**OFFICE OF PROCUREMENT
SIDEWALK REPLACEMENT, ROCKVILLE CAMPUS
RFP NO.: 622-008
RFP CLOSING DATE AND TIME: APRIL 14, 2022 @ 2:00 PM**

**ADDENDUM #1
ISSUED: APRIL 8, 2022**

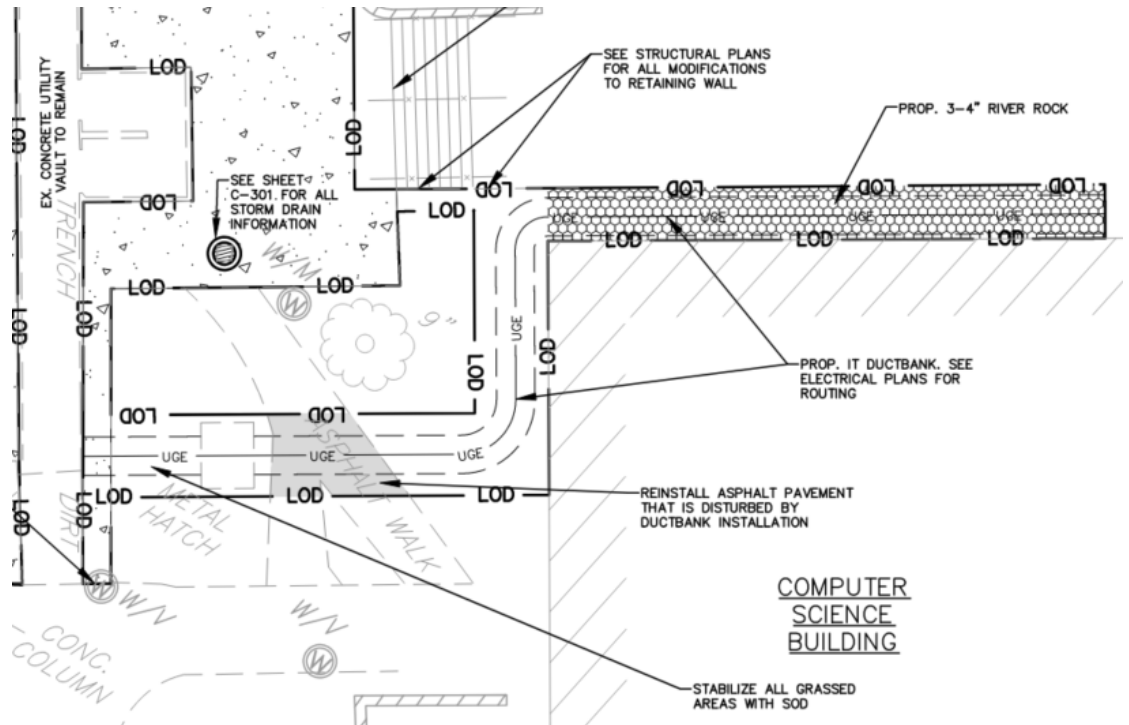
Item 1-1 Question: Computer Science Building - Existing Wall Rail: This may be means and methods but there is an existing wall rail along the North wall of the Computer Science Building where the new telecom ductbank needs to be installed. The access to the excavation area is very limited therefore access may have to be provided from the upper plaza which will require for the wall railing to be removed and re-installed. Please advise if MC will require for all Offerors to assume the removal and relocation of this wall rail.

Answer: It is up to the contractor to remove and replace noted railing. It is assumed the railing is surface mounted and can be temporarily removed at the contractor's discretion.

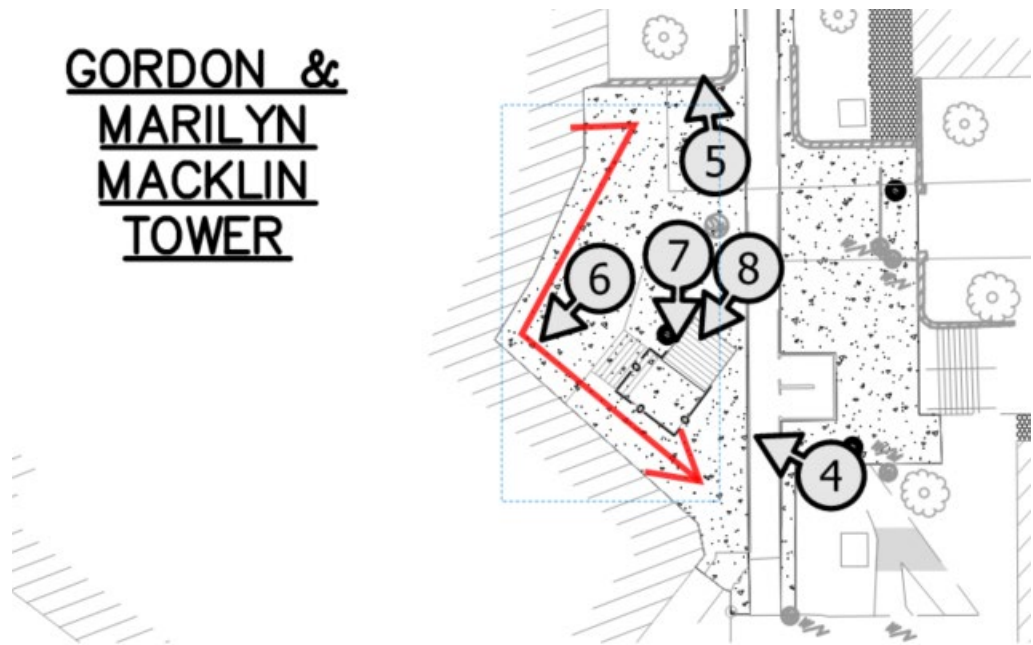
Item 1-2 Question: Access & Egress to Buildings: At the site visit, we noticed that there are several main doors that have been blocked with a temporary security fence. Please confirm that under this Contract, the General Contractor does not have to take into account the means of egress from other buildings. We asked the question at the site visit and it was stated that the contractor for this project should not worry about this concern since the buildings have other means of egress. We were also informed that the only building that we need to be concern with means of egress is the Gordon & Marilyn Macklin Tower. Please review and confirm that maintenance of means of egress are only applicable to the Gordon & Marilyn Macklin Tower.

Answer: Access path noted below is incorrect. The exit door is located where arrow #6 is pointing. See dashed area on sheet C-202 for exact location of egress path. Noted path is to be removed and replaced in between the end of spring graduation and the beginning of summer school and then maintained throughout the remainder of construction. Contractor is to supply chain link construction fence to isolate this area. Please also note that the remainder of the construction work shall be temporarily fenced off as well to prevent pedestrian access to the work areas.
